# Staff Summary Report

**SUBJECT:** Hold a public meeting for a Development Plan Review for **FISHER TOOLS**, located at 1990 E. Third Street.

**DOCUMENT NAME:** DRCr\_FisherTools\_120908

**DPR08240** – Development Plan Review including site plan, building elevations, and landscape plan.

### KEY NOTES

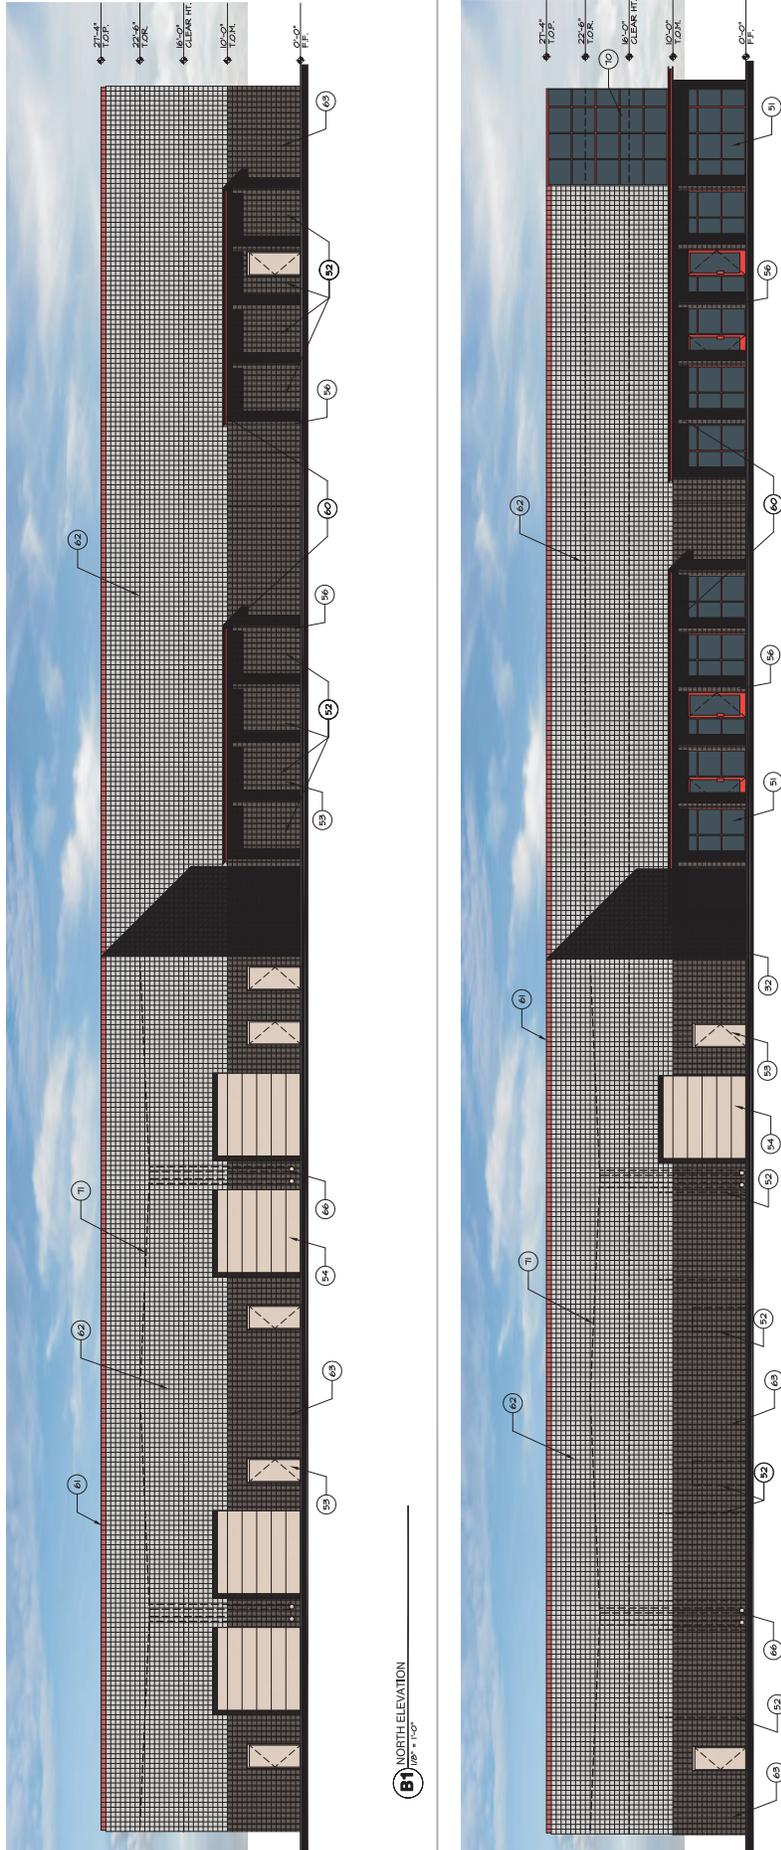
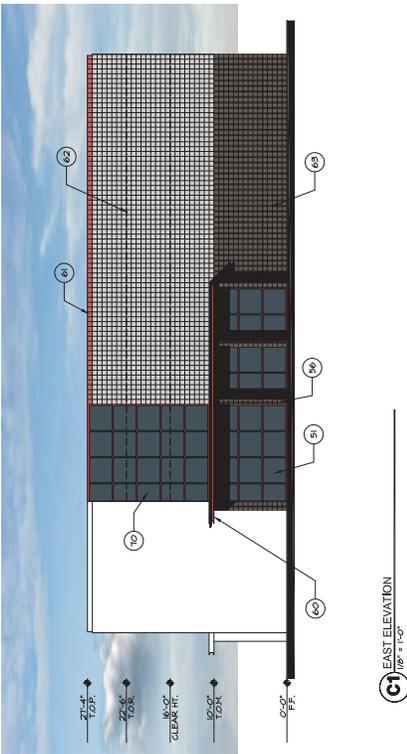
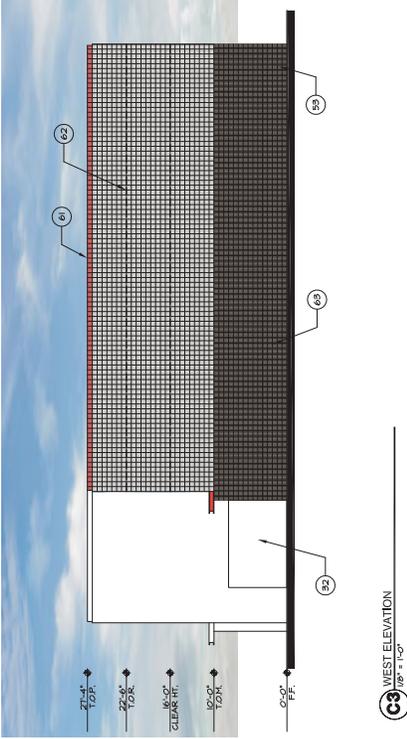
8. The materials and colors are approved as presented:  
Building base (first 10') – Sonoran block split face scored cmu stained in a warm brown to match existing buildings (provide specifications at time of submittal of construction documents)  
Building top (upper 17') color A – painted smooth faced square cmu in Dunn Edwards DE6352 December Sky  
Accent band color B – painted Dunn Edwards Deep Crimson DEA 152  
Window mullions color C – painted Dunn Edwards DEA 106 Deep Contrast  
Provide main colors and materials with a light reflectance value of 75 percent or less. Specific colors and materials exhibited on the materials sample board are approved by planning staff. Submit any additions or modifications for review during building plan check process.

9. Provide secure roof access from the interior of the building. Do not expose roof access to public view.
10. Conceal roof drainage system within the interior of the building.

11. Incorporate lighting, address signs, and incidental equipment attachments (alarm klaxons, security cameras, etc.) where exposed into the design of the building elevations. Exposed conduit, piping, or related materials is not permitted.

**LANDSCAPE NOTES**

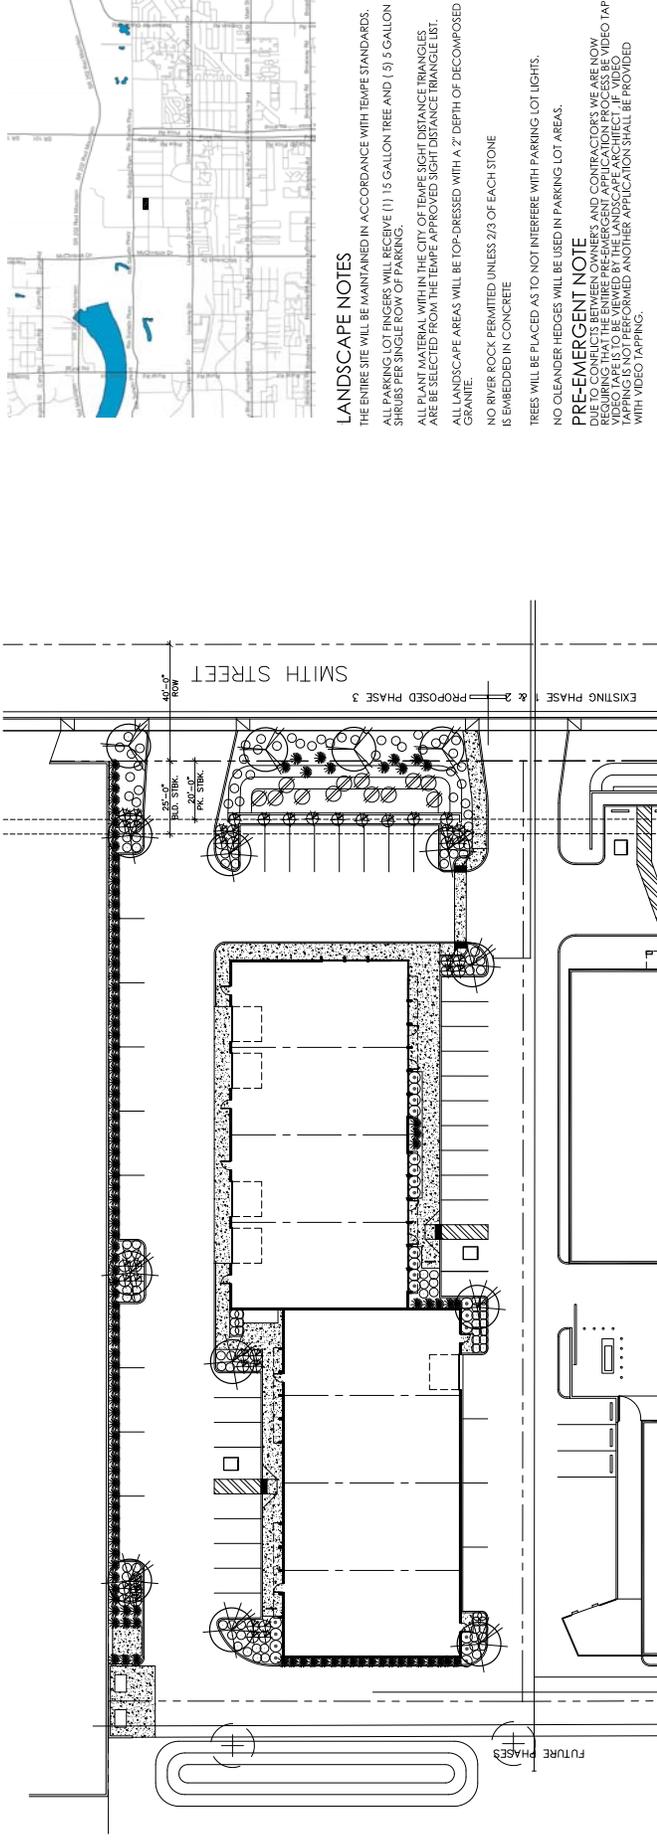
14. Provide street trees along perimeter of developed portion of site on both streets, and upgrade landscape to meet current development standards, or replat the site to accommodate the existing conditions on phase I.

15. The plant palate is approved as proposed and specified on the landscape plan. Any additions or modifications may be submitted for review during building plan check process.

16. Irrigation notes:
  - a. Provide dedicated landscape water meter.
  - b. Provide pipe distribution system of buried rigid (polyvinylchloride), not flexible (polyethylene). Use of schedule 40 PVC mainline and class 315 PVC ½" feeder line is acceptable. Class 200 PVC feeder line may be used for sizes greater than ½" (if any). Provide details of water distribution system.

17. Include requirement to de-compact soil in planting areas on site and in public right of way and remove construction debris from planting areas prior to landscape installation.

18. Top dress planting areas with a rock or decomposed granite application. Provide rock or decomposed granite of 2" uniform thickness or less. Provide pre-emergence weed control application and do not underlay rock or decomposed granite application with plastic.
